DRAFT SEPP 65 and Urban Design Assessment Report

5-7 Wilga Street, Burwood

For Burwood Council

October 2010

Possible
indicative
street scale

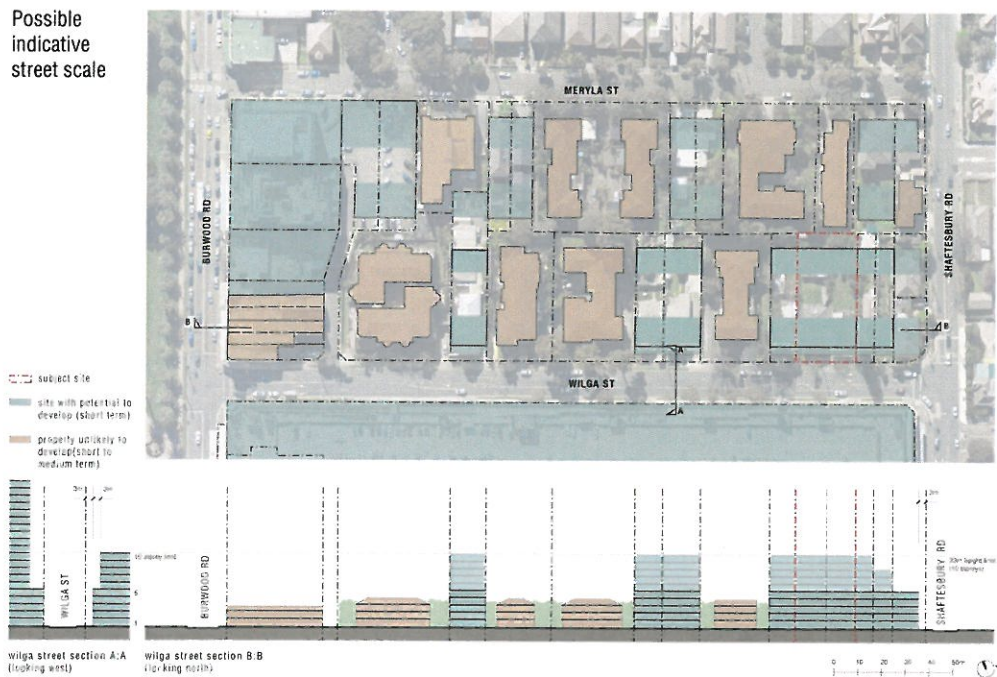
The proposal offers no side setbacks to either of the side boundaries. The resultant development envelope that would be likely to result from the lack of setbacks is that any redevelopment of 9 Wilga Street and of 3, #a, 41, 41A would directly abut the proposed development. On the assumption that it would be possible to develop 9 Wilga Street (which is questionable) this will create a continuous streetwall 10 storeys high for a length of roughly 87m then stepping down to approximately 8 storeys and then to 5 storeys as the height plane affects the sites to the east.

An indicative representation of the envelope that would create is shown below and in the appendix at larger scale.

his approach is not supported for a number of reasons as follows:

- It does not deal with the fact that the existing strata developments in the street are unlikely to redevelop and that this should be acknowledged in the response to the development.

- It creates a continuous streetwall that is not responsive to this likely medium term or possibly long term rhythm of the street as required by the underlying objectives of the Residential Flat Design code (in that it ignores the development pattern in the street that comprises development separated by green space along side boundaries)

- It adopts the continuous streetwall of the Westfield development (but to a much higher scale) which is a totally different development model implied by the new controls – that of a tower and podium form rather than a transitional form from towers to the residential lower scale context beyond.

- It will create a very dominant and long built form if followed as a precedent that would not deliver an appropriate response to scale or context.

Preferred envelope

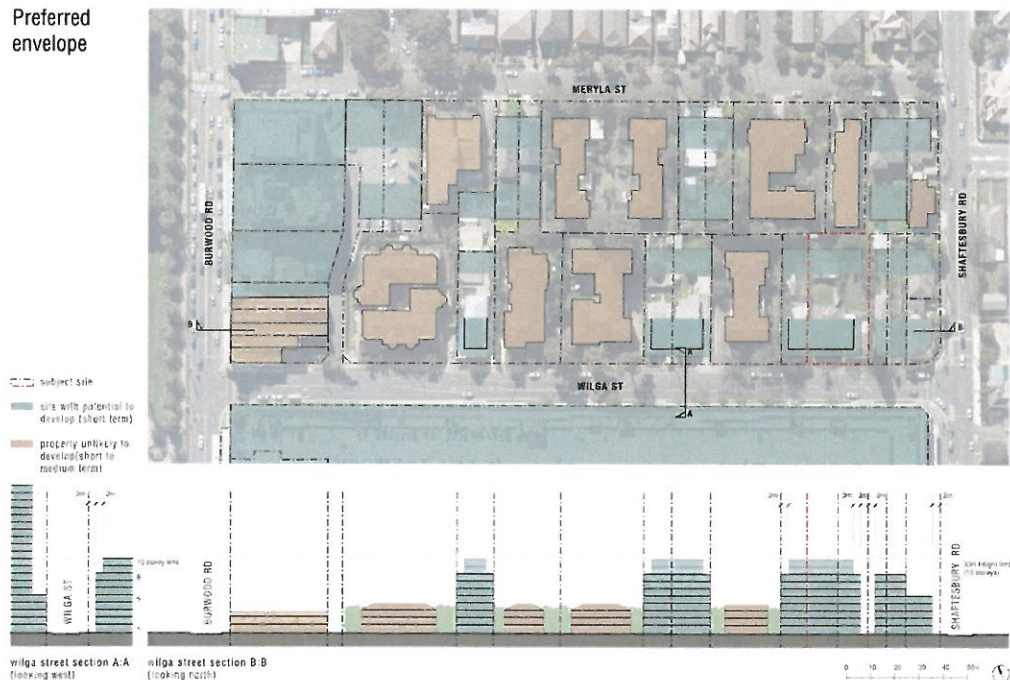
To achieve a more appropriate outcome and response to the street it is considered necessary for there to be a side setback to the eastern boundary of the proposed development. If such a setback was provided it would enable this development and any future development of 9 Wilga Street (assuming the issue above is resolved) to read as one continuous frontage with an overall development width that would not be too out of scale with the rhythm of the street or other development solutions being considered further to the west in Wilga Street. The separation would also allow future development of the remaining three sites to the east to also develop as either one or two developments with some relief in the streetwall scale. A representation of how this might be achieved is shown below and is repeated in the appendix at larger scale.

Preferred envelope for the development site

The image above requires a side setback of 3m to the eastern boundary of the 10 storey built form. A further 3m setback is suggested to the top two floors of the building in addition to this side setback to reduce the apparent scale of the development to something that is more responsive to the scale of the Westfield development (which ranges from the equivalent of approximately 6-8 storeys). This sort of setback to the

upper floors has been recommended and agreed to by the applicant for 17 Wilga Street. This setback should also extend to the top two floors at the front facade of the development so that the top of the building reads as a lightweight setback element.
